International Nuclear Event Scale (INES) Meeting

June 25, 2003

Alan Nelson - NEI

Walter Lee - Southern Nuclear

Defense in Depth Criteria

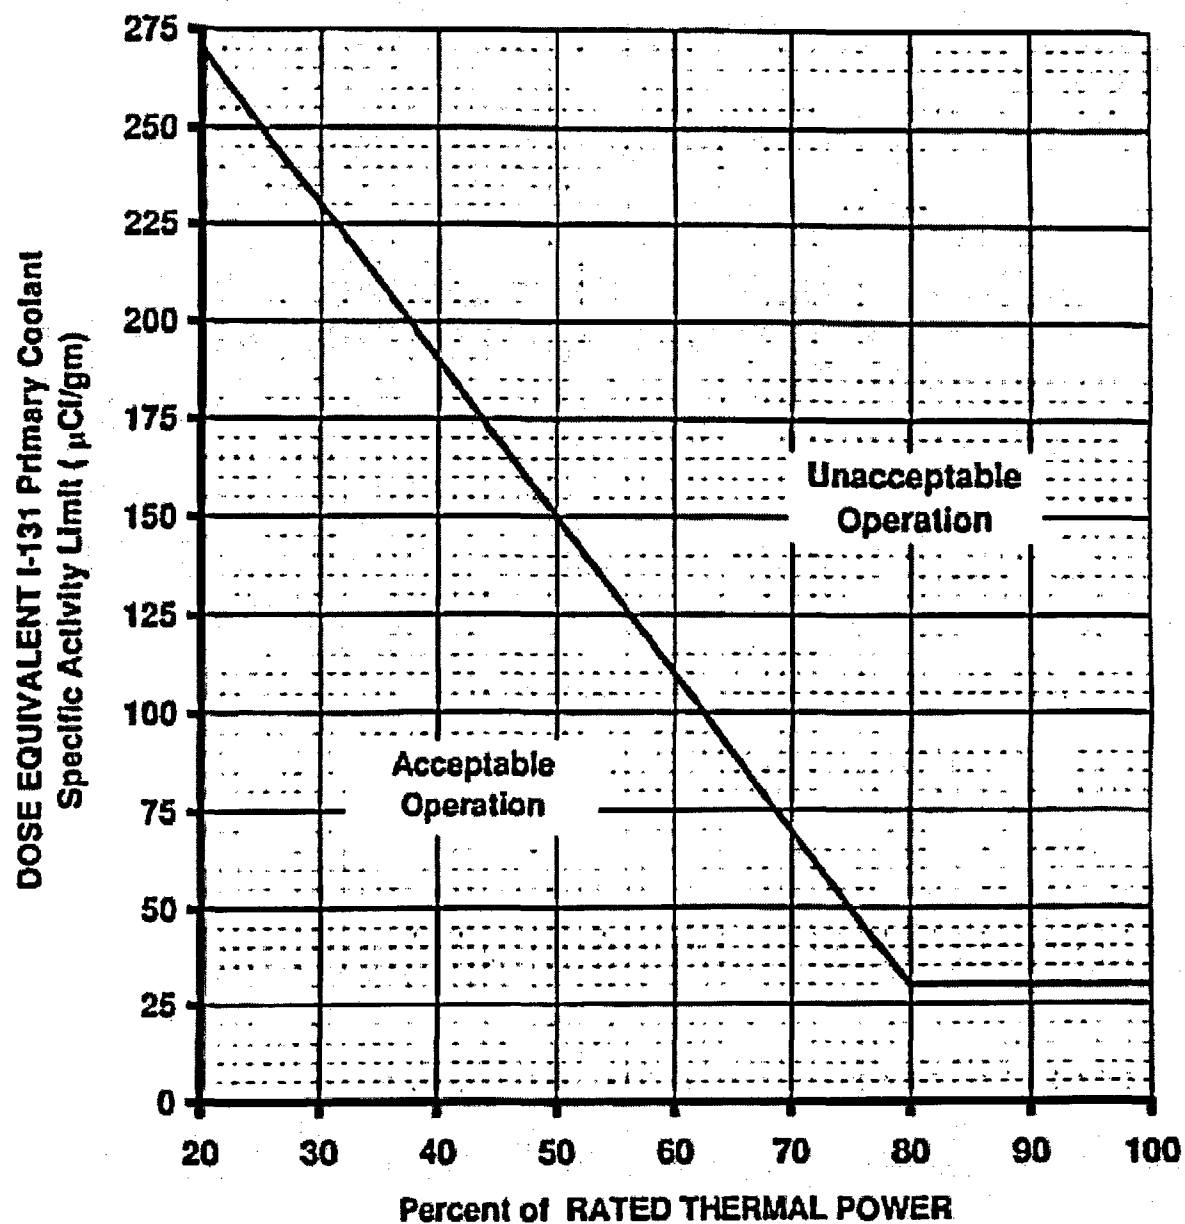
- Has multiple examples provided for the user but excludes examples dealing with RCS activity and clad damage
- Recommend RCS activity examples be added for clarification

- Level 2
 - ◆ DEI elevated into the Unacceptable Operation region of the Technical Specification transient limit requiring shutdown
- Level 1
 - ◆ DEI elevated into the Allowable Operation region of the Technical Specification transient limit for greater than the specified action statement time limit requiring shutdown
- Level 0
 - ◆ DEI elevated out of normal Technical Specification operating limit but returned to within normal operating limit within specified action statement time limit with no shutdown required
